1 **LONDONDERRY, NH PLANNING BOARD**
2 **MINUTES OF THE MEETING OF FEBRUARY 13, 2013 AT THE MOOSE HILL**
3 **COUNCIL CHAMBERS**
4

41 A. Pillsbury Realty Development, LLC, Map 10, Lots 15, 23, 29C-2A, 29C-2B, 41,
42 41-1, 41-2, 42, 45, 46, 47, 48, 50, 52, 54-1, 57, 58, 59, and 62 – Application
43 Acceptance and Public hearing for formal review of the Woodmont Commons
44 Planned Unit Development (PUD) Master Plan [*Continued from the January 9,*
45 *2013 Planning Board Meeting.*]

- 46 • Presentation and Discussion: Transportation, Open Space Framework,
47 Definitions and Glossary of Terms
48

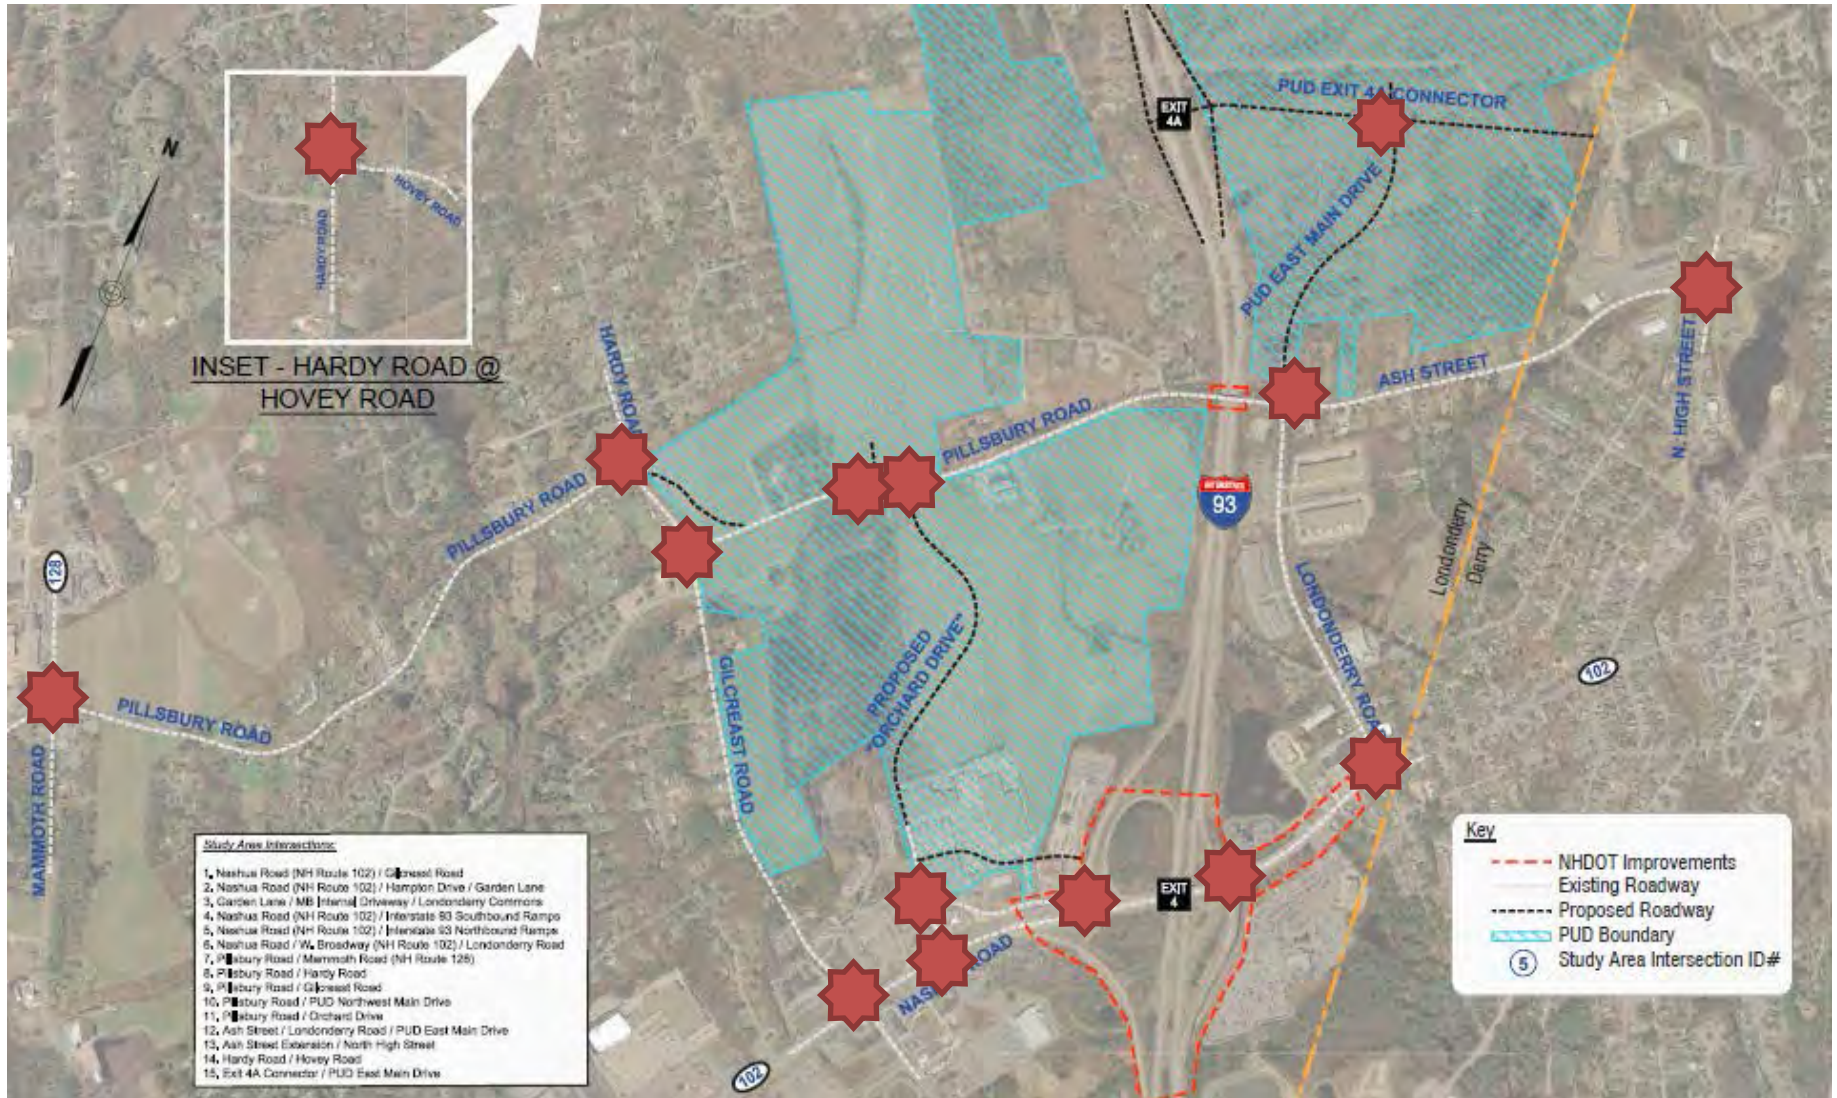
20
21 **M. Newman asked how, if at all, the three way stop intersection**
22 **currently north of Rt. 102, between Wendy's and Citizen's Bank, would**
23 **be modified if the "Potential New Driveway Connection" dotted in**
24 **white on page 14 of the Briefing PowerPoint would be modified.**
25

38 something that we show as a master plan because that's what we should be
39 doing is looking at another potential connection to the north on the west side
40 of that road where that opens up another outlet for that whole side. And that's
41 part of what we do as the planning is to make sure that we have those sensible
42 internal connections, not only within our project, but the things that might
43 make sense to our abutters to consider as well."
44

Route 102 / Gilcreast Road / Garden Lane

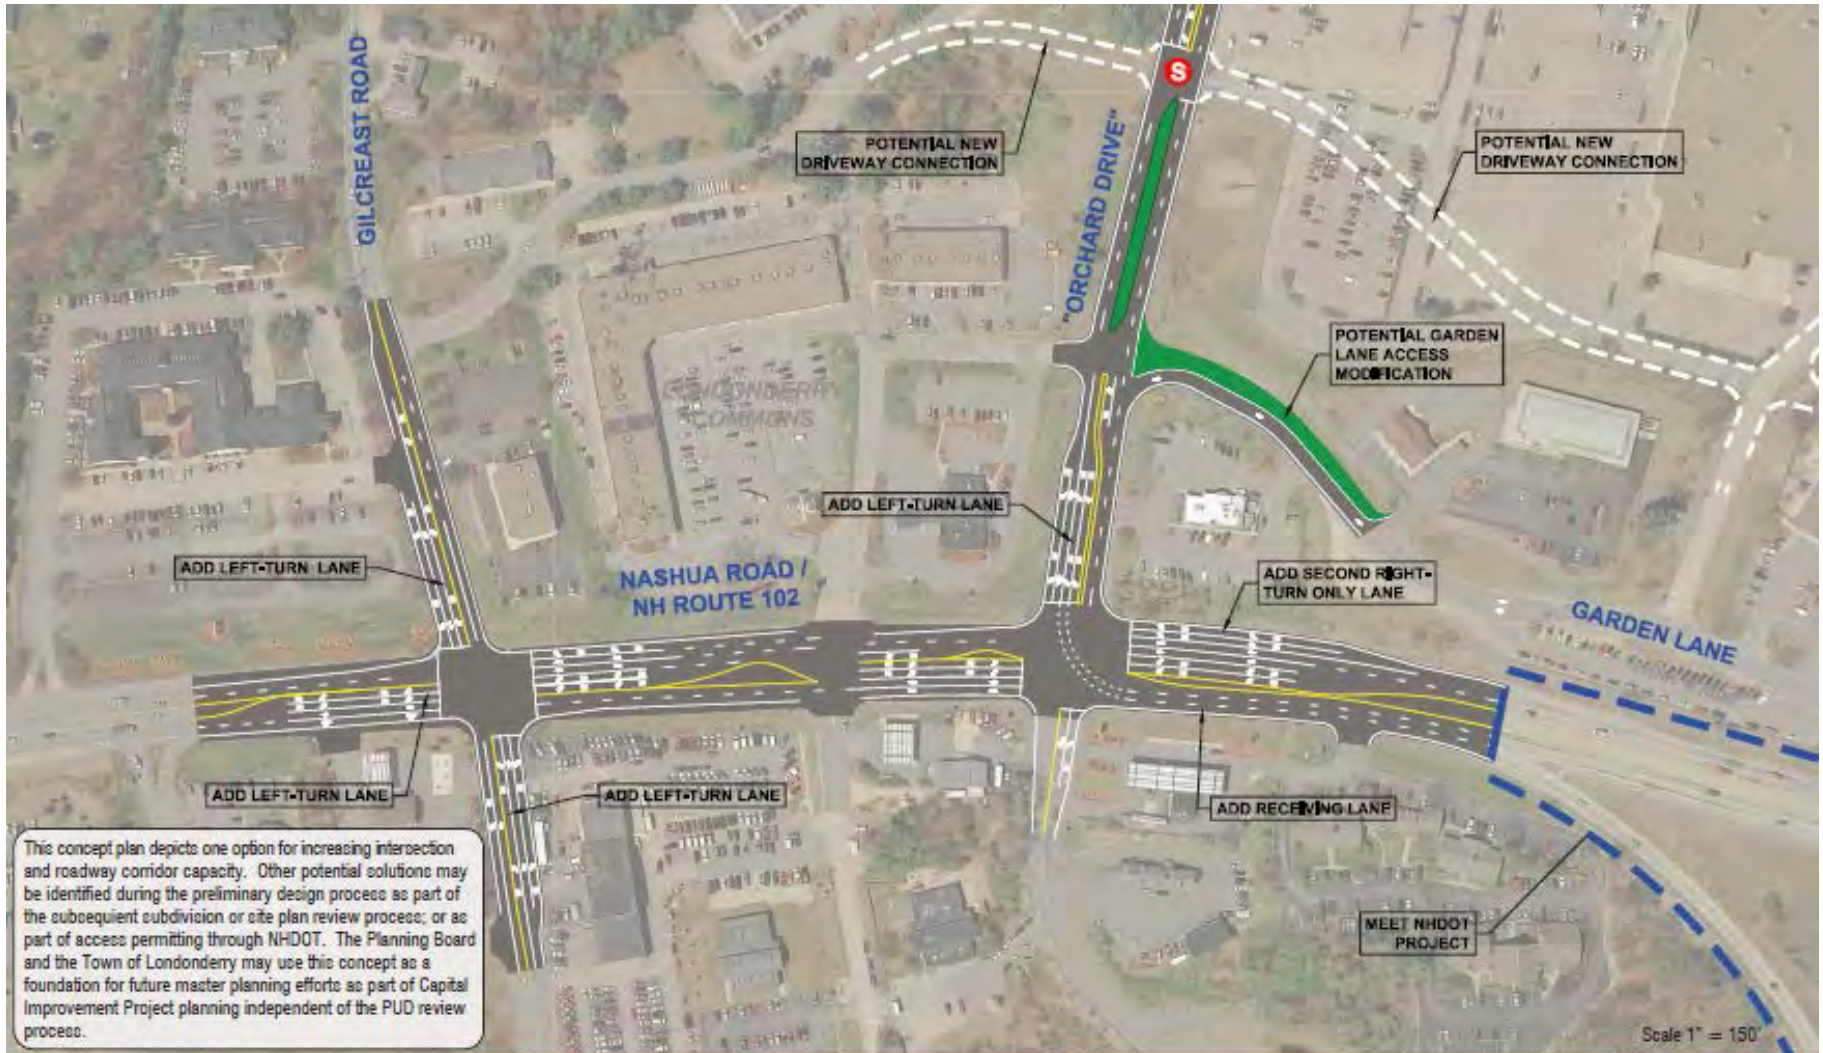
47 (K. Dandrade) "The singular asterisk [on] the third line down, 'Garden
48 Ln/Londonderry Commons/Orchard Drive;' it assumes the relocation of Garden
49 Lane to increase the distance. Some of this will be put in better perspective
50 when I show the graphic in a moment. The double asterisk for the Northwest

27 **M. Soares asked if the "Potential Garden Lane Access Modification"**
28 **was showing that street as an entrance only off of Orchard Drive.** K.
29 Dandrade explained that at this point, it is the option chosen because of a
30 difference in grade of approximately 12 feet from the corner of Garden Lane
31 north to the detention basin. Reconfiguring Garden Lane and changing its
32 location would create more impact. The design presented still allows for
33 circulations of vehicles around the site. Since this would potentially impact
34 access out of Wendy's, **M. Soares then suggested the team approach**
35 **Wendy's as well as the Londonderry Commons businesses.** **J.**
36 **Laferriere added that DOT should be consulted because of the Park and**
37 **Ride to the east.** K. Dandrade confirmed it would be done.
38
